P24-2210_EN_19 - REFUSED SCHEME LANDSCAPE & ECOLOGICAL MASTERPLAN (not to scale)

P24-2210_EN_20 - AMENDED SCHEME LANDSCAPE & ECOLOGICAL MASTERPLAN (not to scale)

LAND NORTH OF CANWORTHY WATER - COMPARISON BETWEEN REFUSED & AMENDED SCHEME

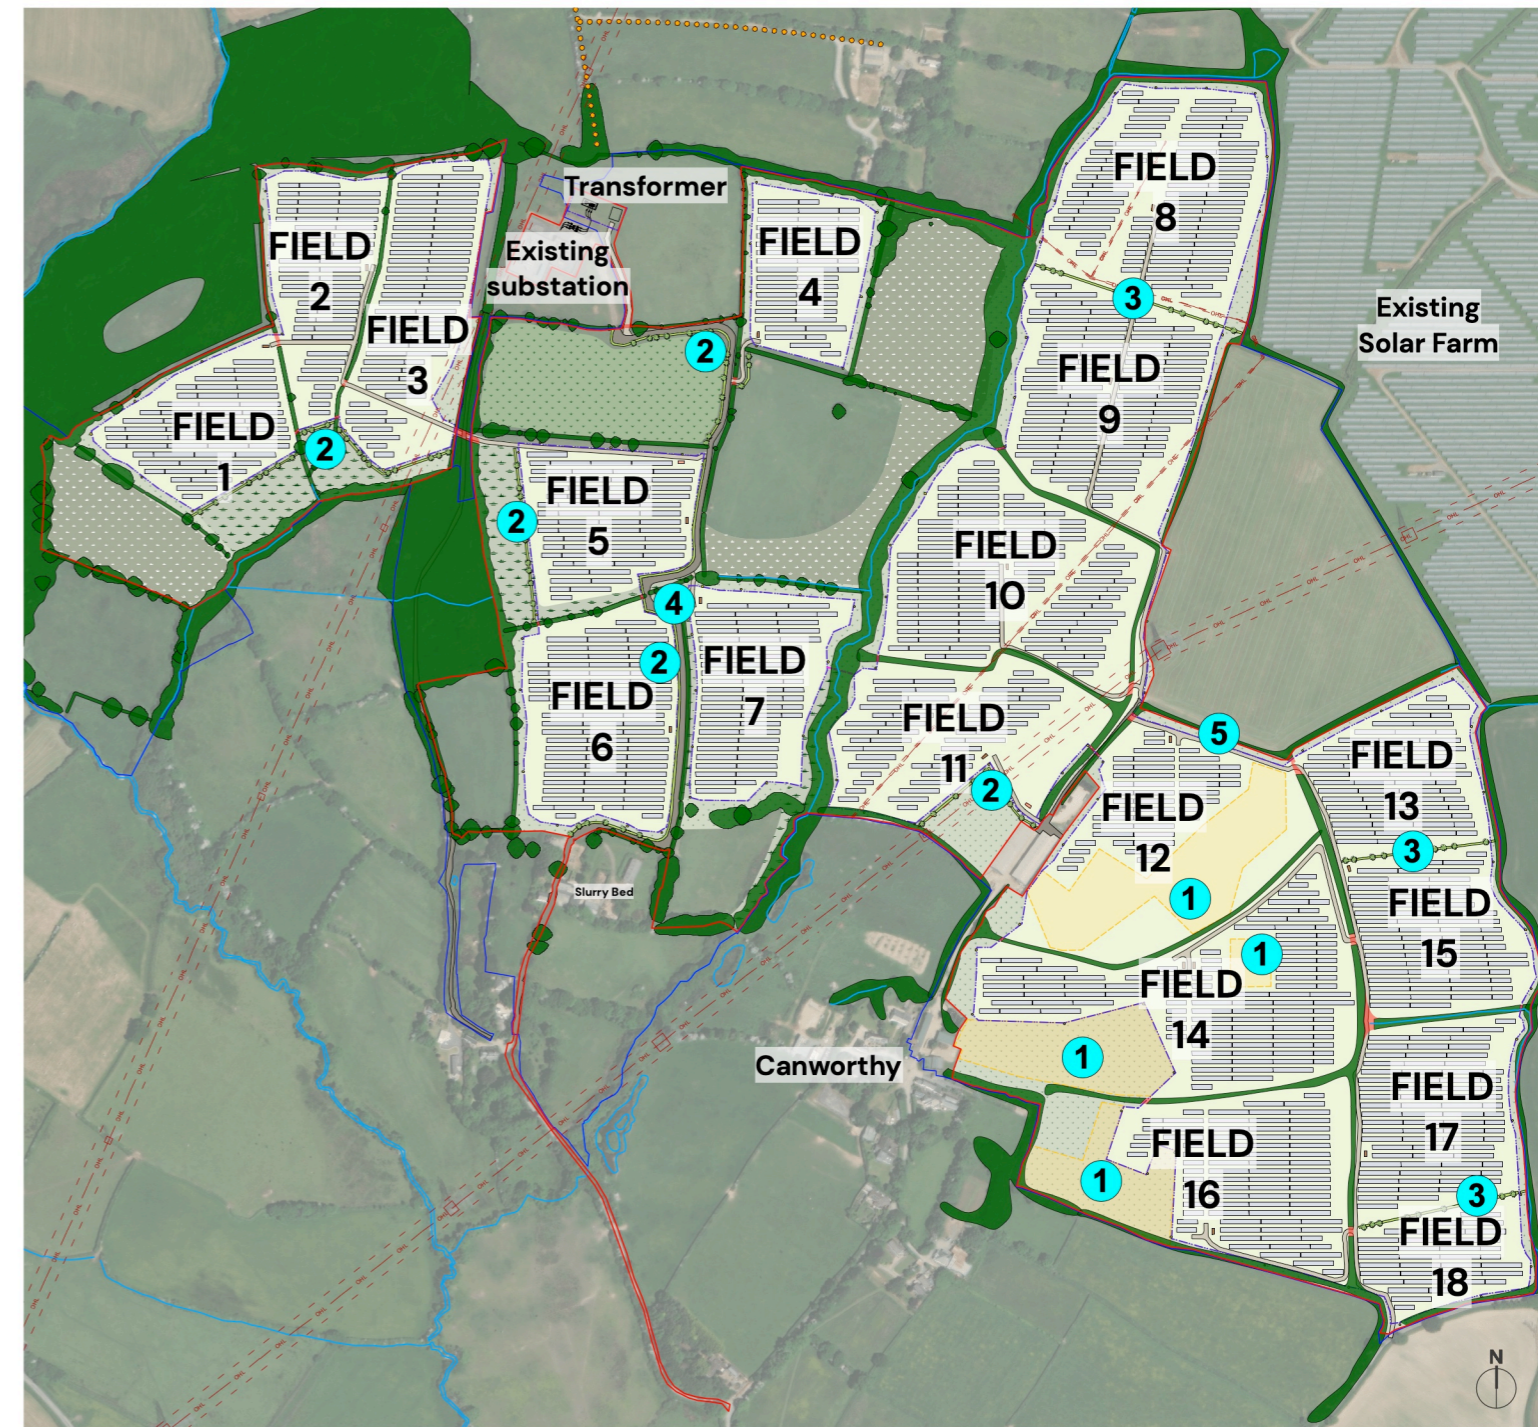
- 1 - Development omitted from areas of highest archaeological sensitivity
- 2 - Native hedgerows proposed to edges of solar compound extents to screen views into the development, strengthen landscape character features within the landscape, and improve habitat connectivity for local wildlife

- 3 - Native hedgerows proposed to break down massing of the development, strengthen landscape character features within the landscape, and improve habitat connectivity for local wildlife

- 4 - Fence lines amended to allow access along existing track outside of panel fenced compounds
- 5 - An access track to the north of the hedgerow of solar panel array field 12 has been removed. The proposed access track south of the hedgerow of solar panel array field 12 has instead been extended to the north west to connect with the proposed access to the east of solar panel array field 10. The proposed fencing now also follows the track south of the hedgerow.

Minor amendments to the panel extents have also been made site wide as a result of incorporating additional proposed landscape features. All amendments have been contained within the existing Appeal Site boundary
